**SUBDIVISION COMMITTEE
METROPOLITAN AREA PLANNING COMMISSION**

**STAFF REPORT
(One-Step Final Plat)**

CASE NUMBER: S/D 98-7 - WSM PROPERTIES ADDITION

VICINITY MAP

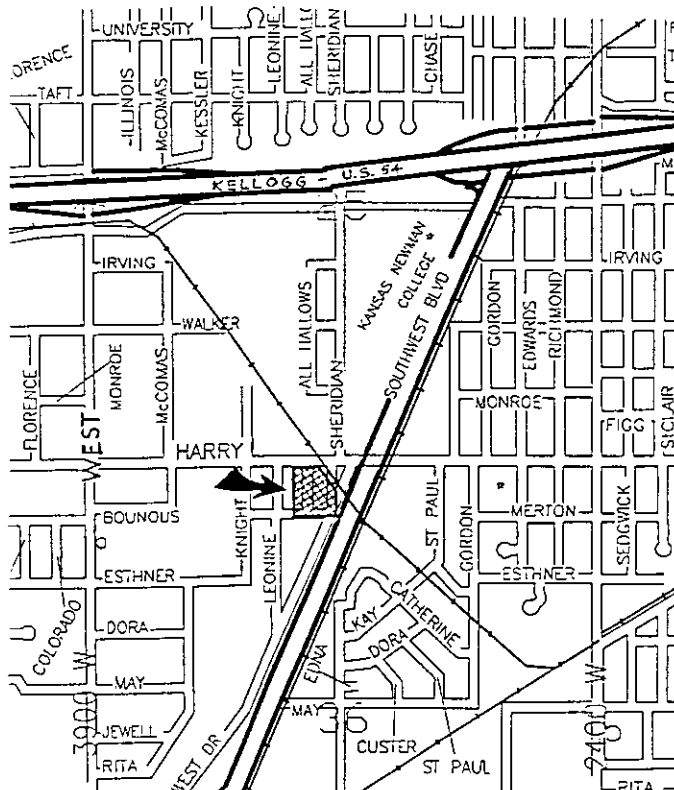
*Relocation of SS
or Show 20' easement
2' Alley R/W*
